# ON-SITE SEWAGE FACILITY APPLICATION

Permit Number 116147

**AEROBIC TREATMENT  
DRIP TUBING SYSTEM**

**Re: Y & JR Homes Master LLC  
Replat of Comal Hills Unit 1 Lot 395 Block 1  
Application for Permit for Authorization to Construct an On-Site  
Sewage Facility (OSSF)**

# CHISOLM TRAIL

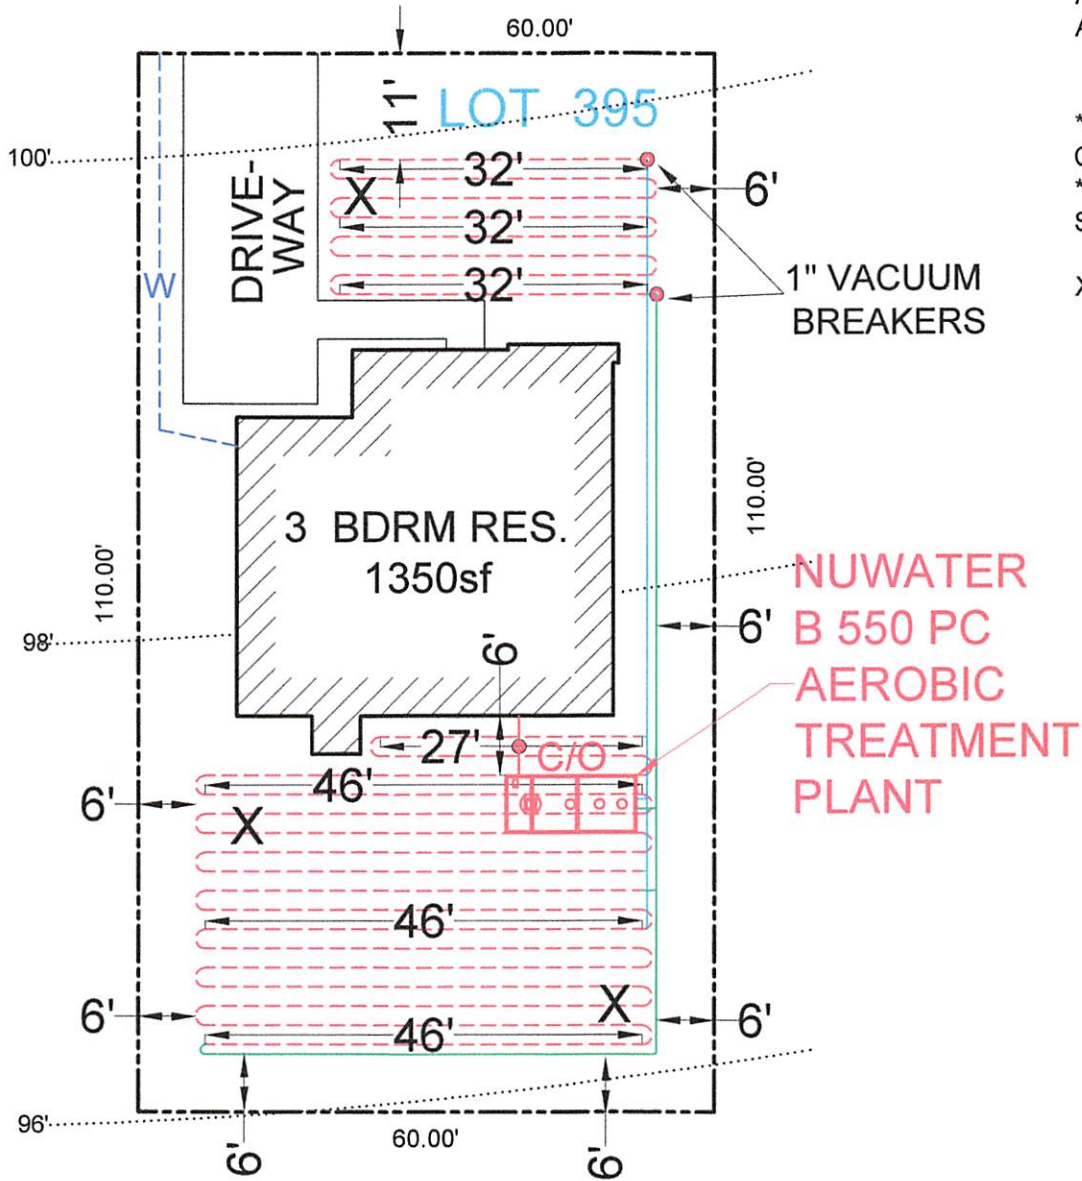
- 1. A minimum of 12 inches of soil is required between the drip tubing and the top of the ATU/tanks.**
- 2. Revise as needed and resubmit.**
